**Proponent Submission by SJB Planning to
the 6 November 2023 Transport, Heritage
and Planning Committee**

Subject: Item 5 - Planning Proposal - 85-93 Commonwealth Street, Surry Hills - Sydney LEP 2012 Amendment

Figure 1: 4.5:1 FSR

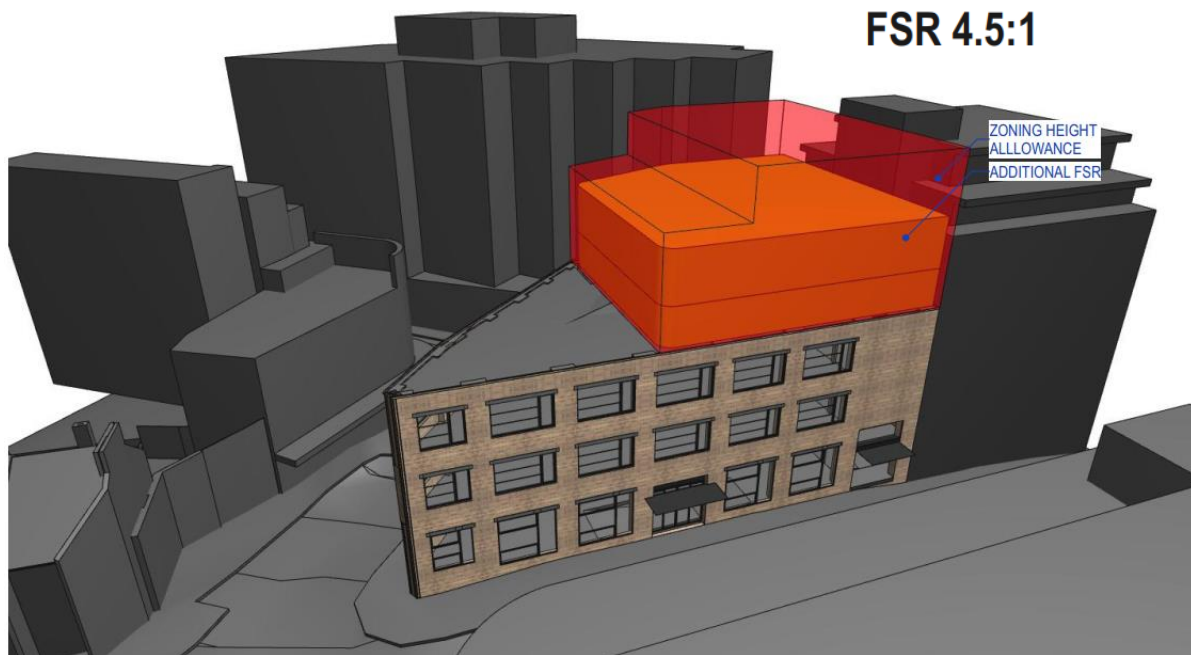
3. The proposed envelope has been amended to ensure that there are no overshadowing impacts on neighbouring properties and public spaces. The maximum FSR of 4.5:1 readily fits within this envelope as illustrated in Figure 1.

We request that the maximum 4.5:1 FSR control be reinstated, without the requirement for a Design Competition to be held.

Figure 2: 4.1:1 FSR

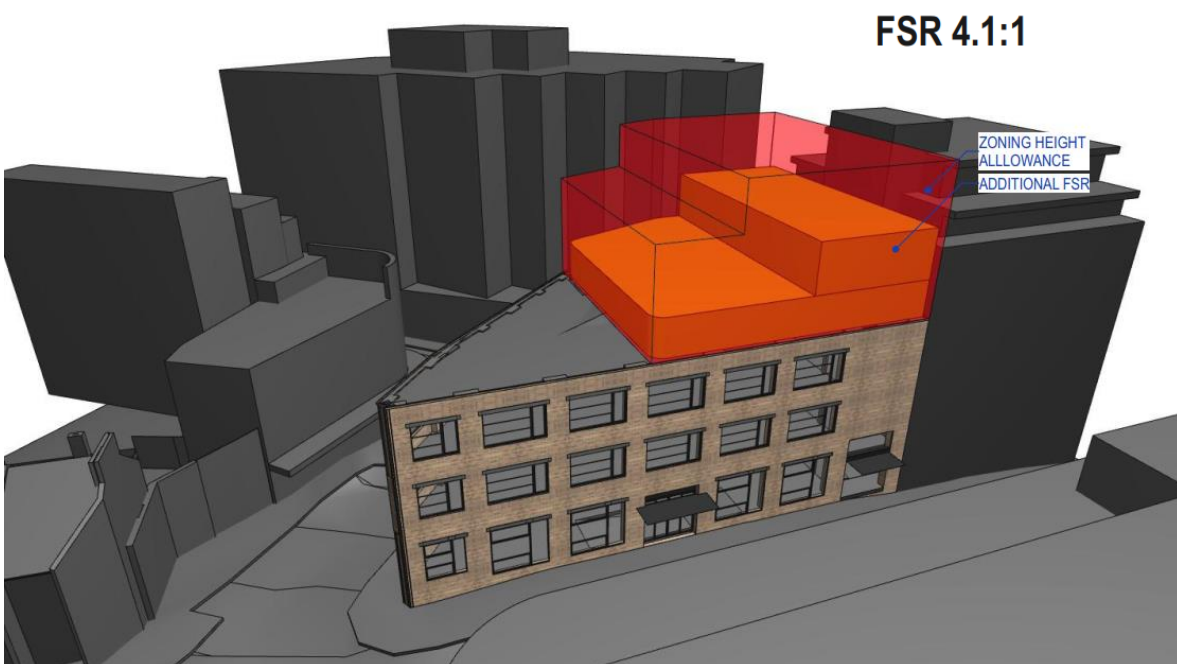
6. The imposition of a 4.1:1 base FSR, means a 2 storey addition cannot be realised without going through a Design Competition as illustrated in Figure 2.
